PRODUCT RETROFIT NOTICE

3M™ DBI-SALA ADJUSTABLE BARREL MOUNT DAVIT SLEEVE (OSHA& CE)

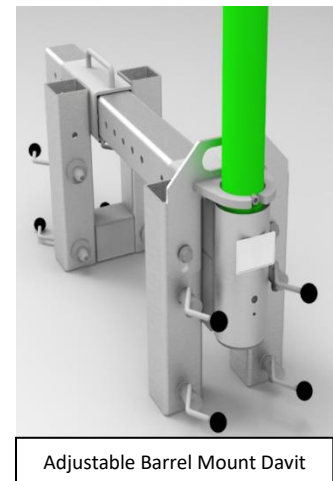
3M Fall Protection has determined that the barrel mounts do not fully meet all load claims in all adjustment positions as represented in the “Instruction for Use” (IFU) manual and on product labels. There have been no reported accidents or injuries associated with this issue. This issue only affects the following part/model numbers identified on the product labels of the units: 8512285, 8562285, 8510715, and 8516088.

To address the issue, 3M Fall Protection has developed a design modification to one component of the barrel mount. This modification will restrict the adjustment of the davit arm to the perpendicular position when used for Fall Arrest purposes. For Rescue purposes, the full adjustment range of up to 180 degrees is not affected. In addition, the design modification has reduced the rated capacity (working load) of the barrel mount to a 310 lbs user. The modification is incorporated in all systems manufactured after November 10, 2017 and will be available as a retrofit at no cost to all end users who purchased their systems prior to November 10, 2017.

End-users: If you have an affected unit, please contact Customer Service at 800-387-7484 (prompt #5908) or email 3MCAFPServiceAction@mmm.com to receive your Retrofit Kit free of charge. Retrofit Kit P/N 8547945. If you provide us with your contact information, shipping address, and part/model details of the product you have, we will send you the Retrofit Kit free of charge. When you receive the Retrofit, please locate the updated IFU, which can be found at <http://capitalsafety.webdamdb.com/viewphoto.php?&albumId=562594&imageId=15807097>
